Access Compliance Report Public Rights-of-Way (RR Crossings)

Intersection ID: 10025521	Main Street: E_PARK_AV	Location: N/A
ADA ID: 4DC5EC2DE865	Overall Compliance: No	Severity Score: 0.0
Codes/Mitigation Info/Possible Solution		Field Measurements/Component Compliance

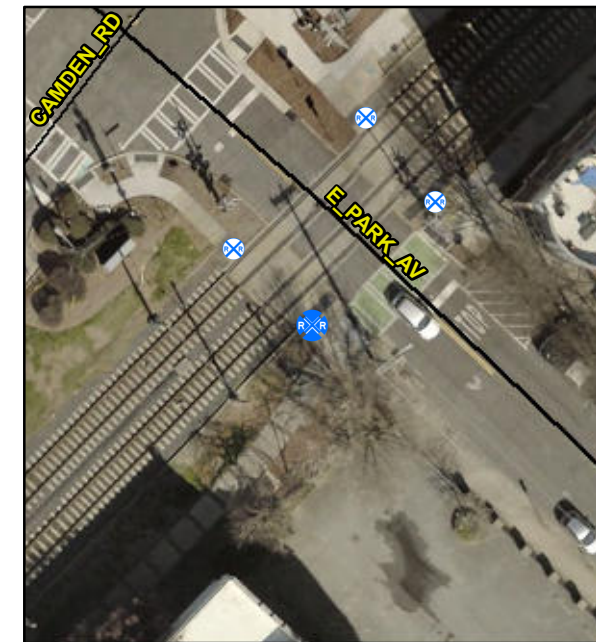
R302.7.4, R305.2.5

Compliance	Description	Data
Yes	DWS Provided?	Yes
Yes	DWS Contrast?	Yes
Yes	DWS Width (in)	Yes
Yes	DWS Length (in)	36.0
No	DWS Offset (in)	29.0
No	Pedestrian Gate?	No
N/A	DWS Outside Gate?	No
N/A	Rail Type?	LightRail
No	Flangeway Gap (in)	3.0
Yes	Sidewalk Width (in)	100.0

**Remove & Replace Detectable
Warning System. Provide Pedestrian
Gate. Remove & Replace Walking
Surface Adjacent to Rail.**
